# MATANUSKA-SUSITNA BOROUGH

**PLATTING BOARD AGENDA**  
**ASSEMBLY CHAMBERS**  
**350 E DAHLIA AVENUE PALMER**

**February 5, 2026**

PRELIMINARY PLAT: VANDA VALLEY MSP  
LEGAL DESCRIPTION: SEC 19, T18N, R01E, SEWARD MERIDIAN AK  
PETITIONERS: KOV'S LLC  
SURVEYOR/ENGINEER: HANSON LAND SOLUTIONS  
ACRES: 49.29 ± PARCELS: 38  
REVIEWED BY: CHRIS CURLIN CASE #: 2025-128

TEST HOLE LOCATION EXHIBIT MAP

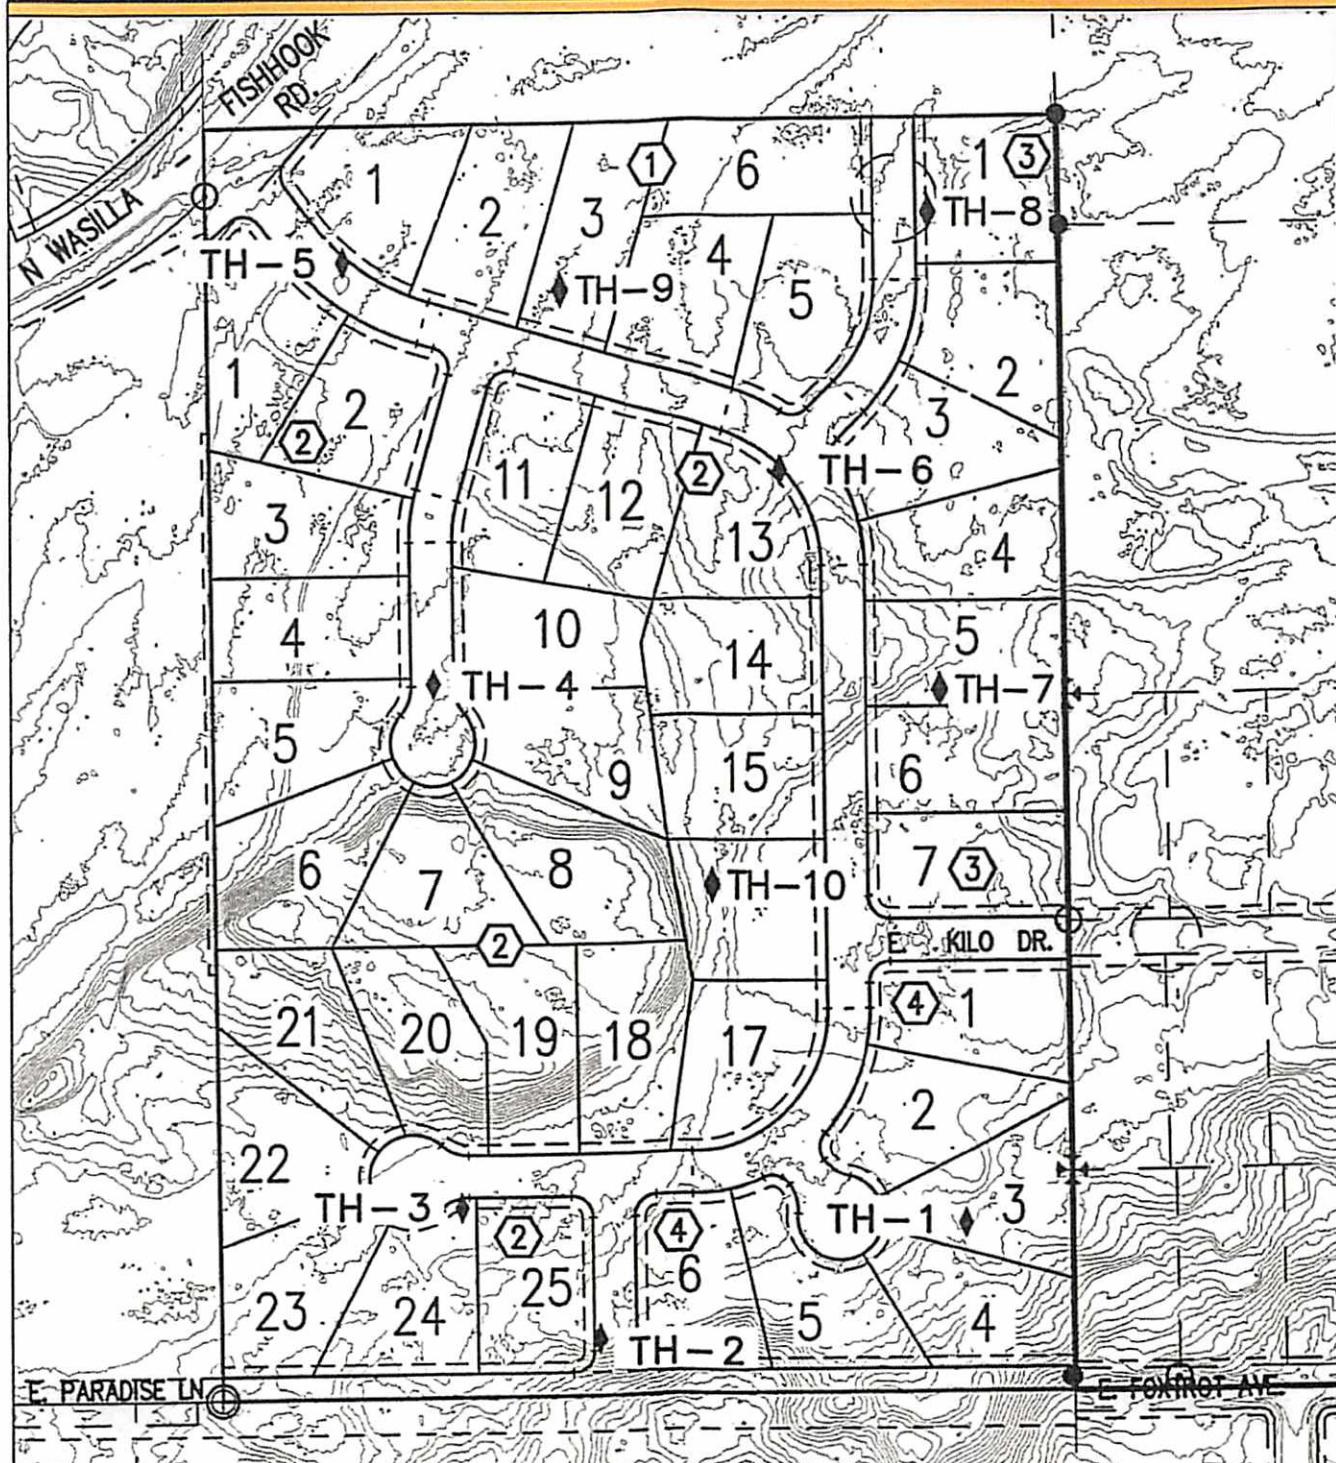
PD&E comments test hole 8 on Lot 1 Block 2 shows ground water less than 8 feet below ground. Please delineate where the usable septic area is on Lot 1 Block 2 and the surrounding lots or provide additional information or evidence that each lot has 10,000 square feet of contiguous usable septic area.
